# AIRPORT LAND USE COMMISSION RIVERSIDE COUNTY AGENDA

Thursday 9:00 A.M., February 9, 2017

**ADDENDUM TO HEMET-RYAN AIRPORT LAND USE  
COMPATIBILITY PLAN POLICIES**

## Draft Hemet-Ryan Airport Land Use Compatibility Plan Addendum #1 - Draft

# Hemet Ryan Airport Land Use Plan Open Land Areas

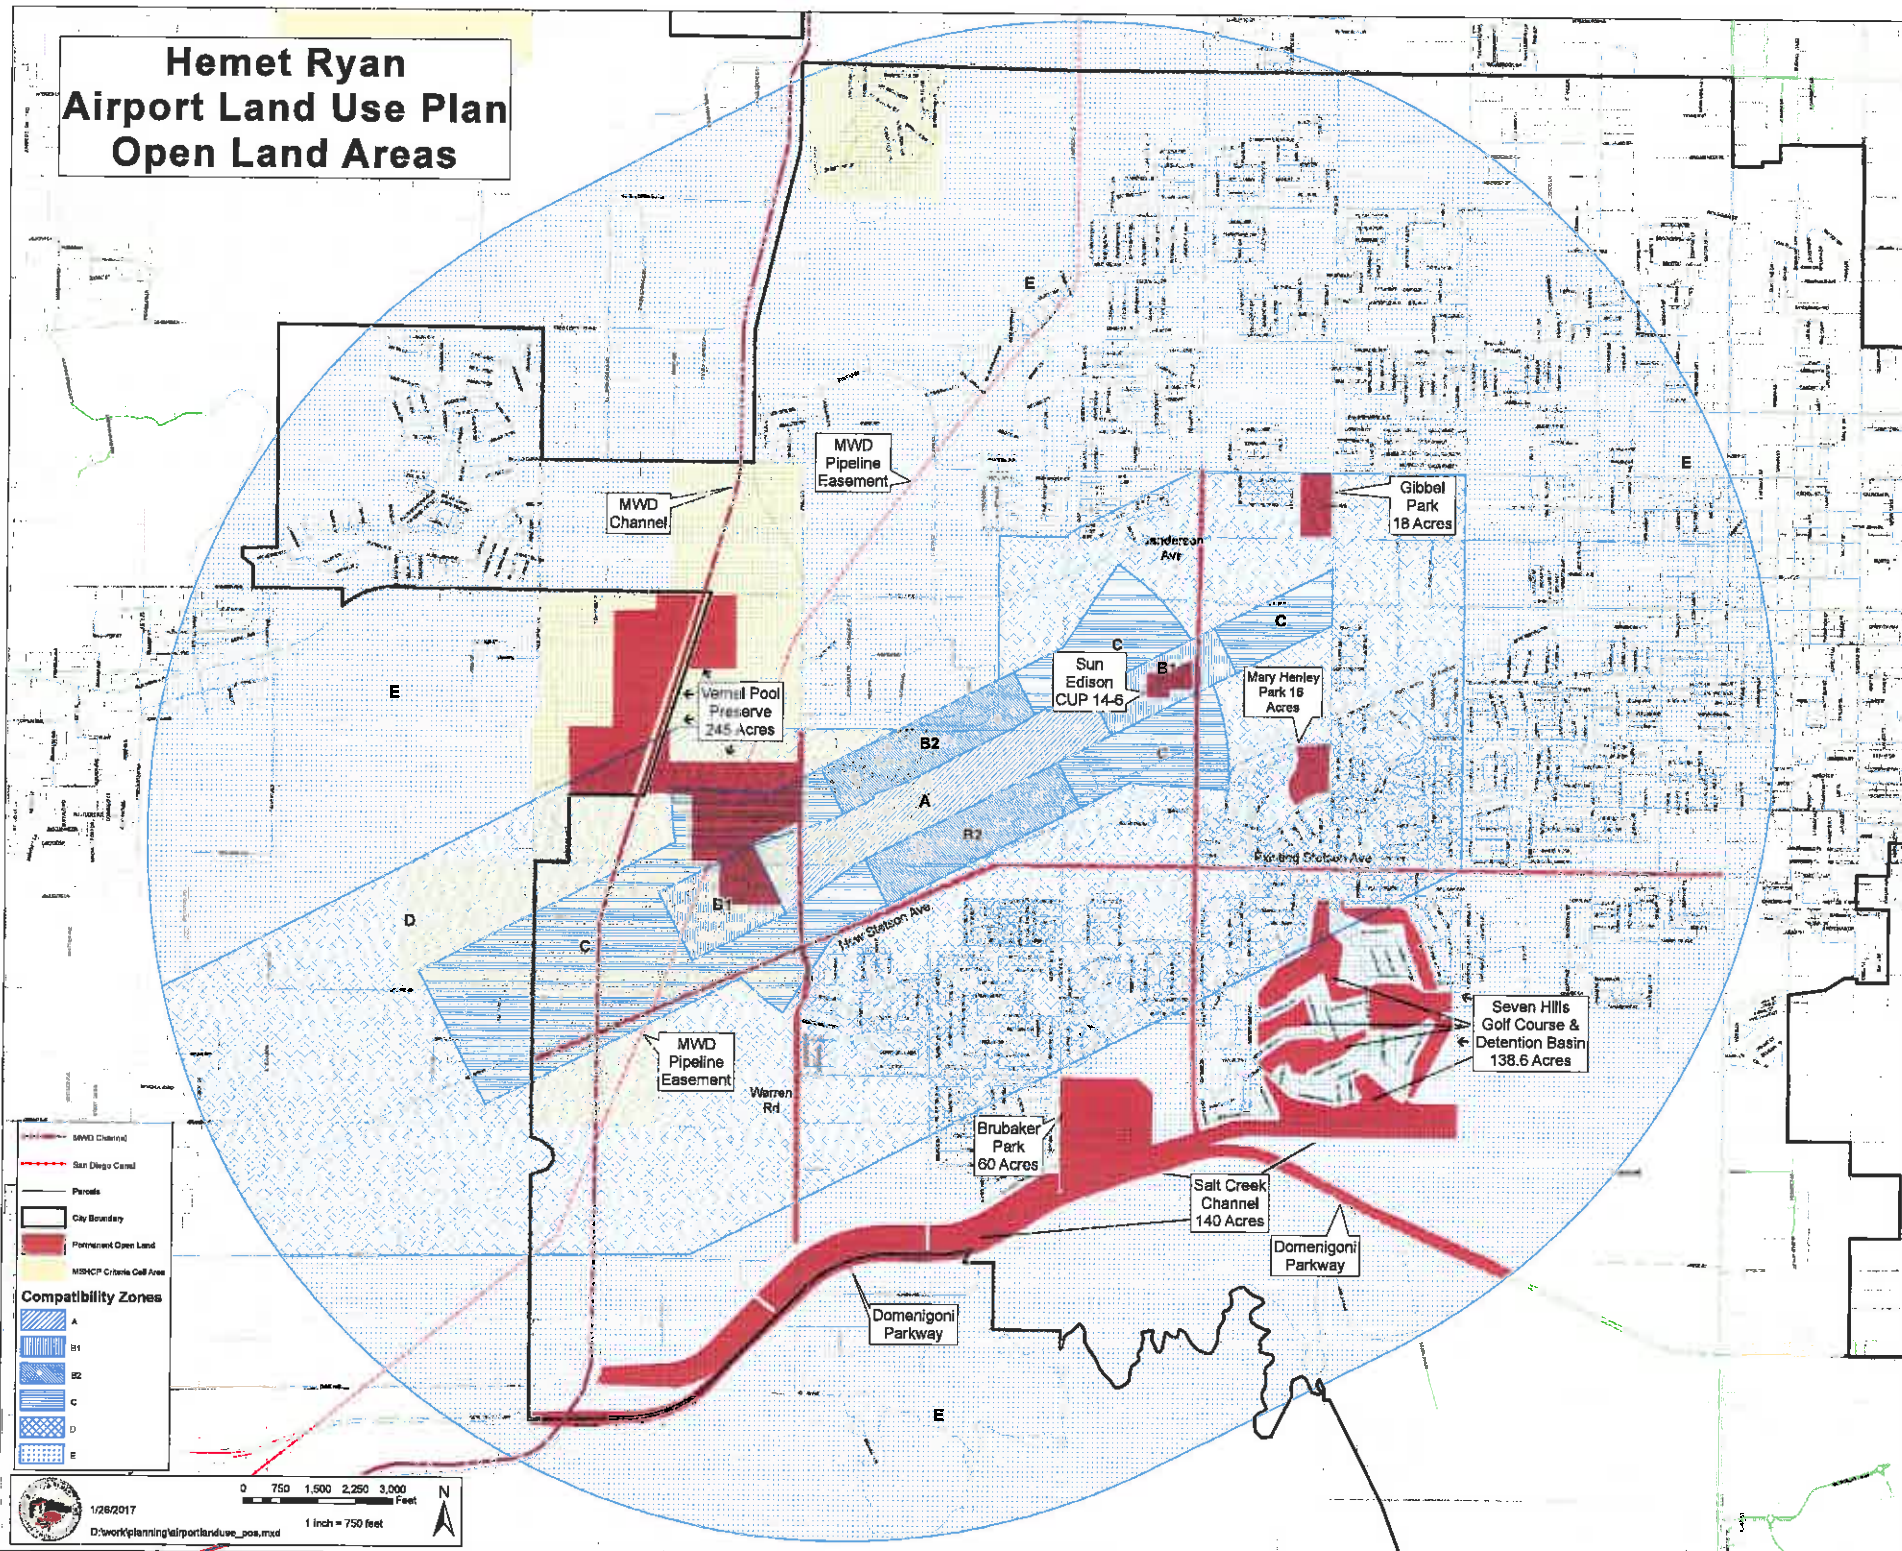
- (b) Compatibility Zone C— Within the portion of Compatibility Zone C westerly of Zone B2 and the westerly terminus of Runway 5-23, the open land areas depicted on **Map HR-4** satisfy the open land requirement for that portion of Compatibility Zone C. Therefore, individual land use development projects within the portion of Compatibility Zone C westerly of Zone B2 and the westerly terminus of Runway 5-23 are not required to provide additional open land. However, there is insufficient public open land to meet open area requirements in the portion of Compatibility Zone C easterly of Zone B2 and the existing (as of January 1, 2017) easterly terminus of Runway 5-23. Therefore, within this easterly portion of Compatibility Zone C, the open land requirements of **Table 2A** of the Countywide Policies are applicable to individual parcels.

- (c) Compatibility Zone D—Based on the open land areas depicted on **Map HR-4**, the open land requirement in Compatibility Zone D is satisfied. Therefore, individual land use development projects within Compatibility Zone D are not required to provide additional open land.

Exhibit HR-7  
**Compatibility Factors Map:**  
**Safety and Airspace**  
**Hemet-Ryan Airport**

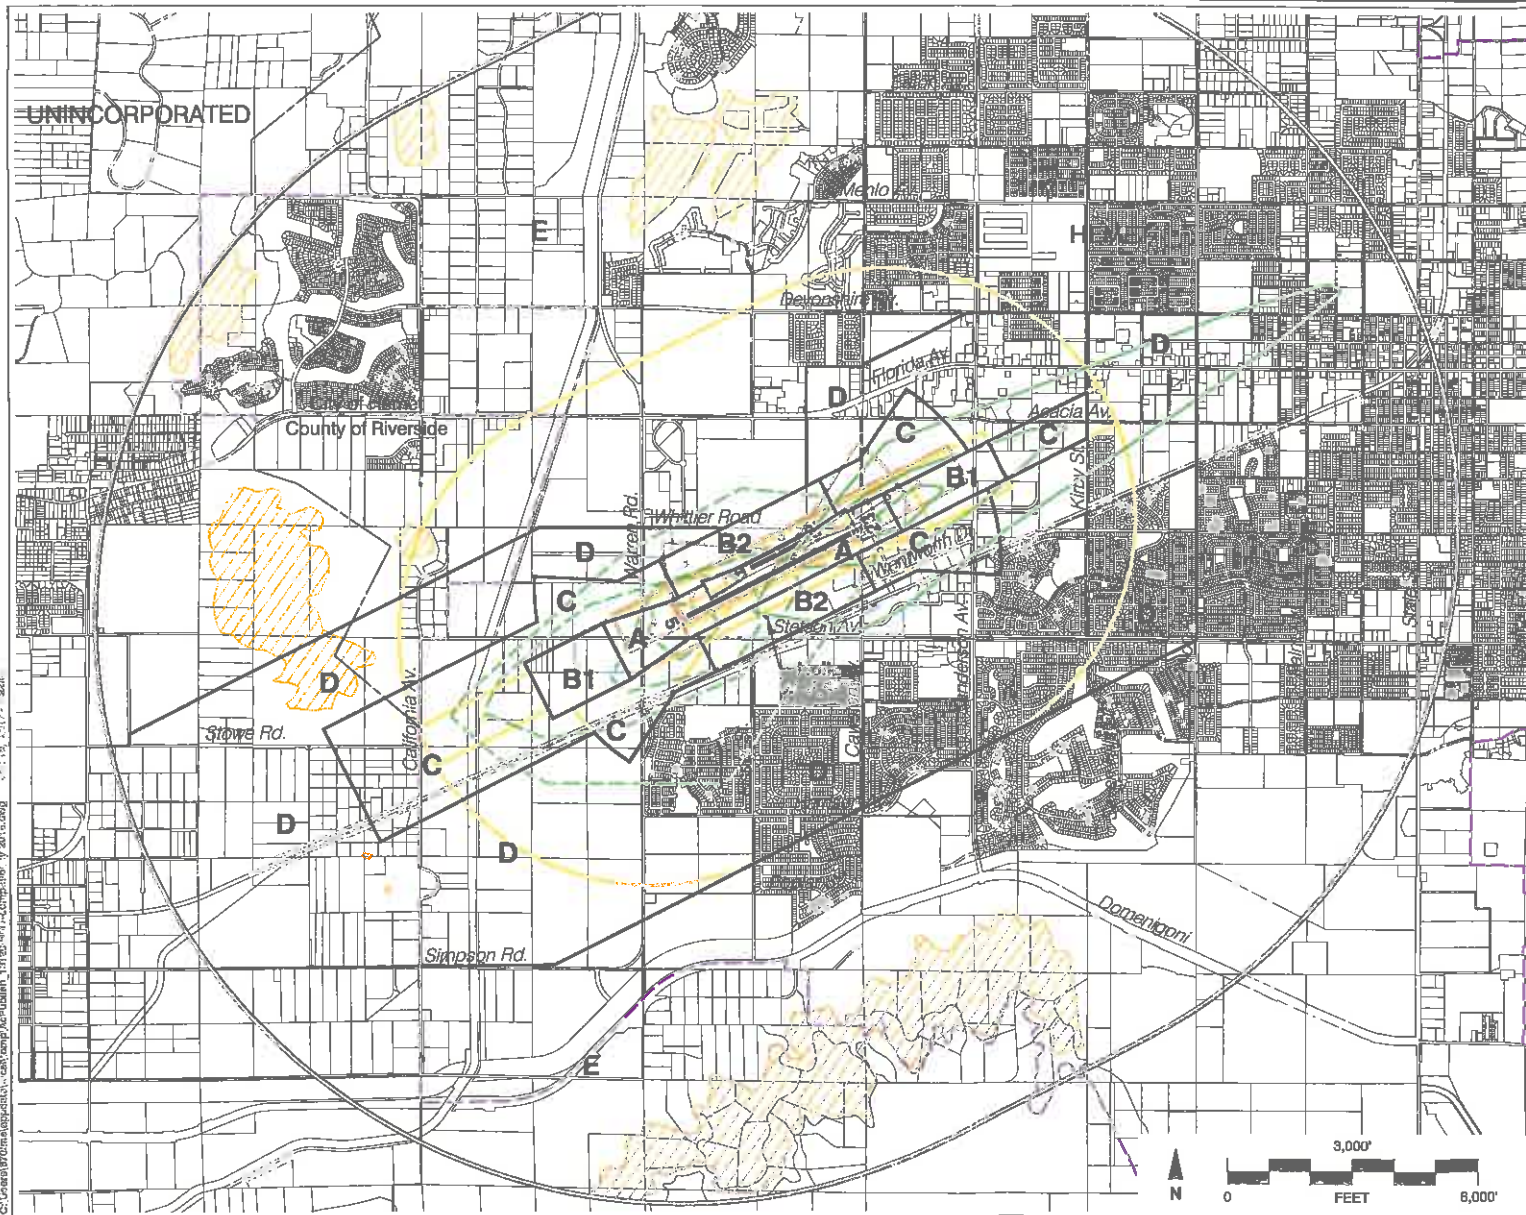
*Exhibit HR-7, Compatibility Factors Map—Safety and Airspace: As shown on the accompanying map, correct the position of the generic safety zones at the eastern end of the primary runway to be based on the existing runway end. Add the following Note 3: "Location of zones at eastern end of runway based on current runway end which will become future displaced threshold."*
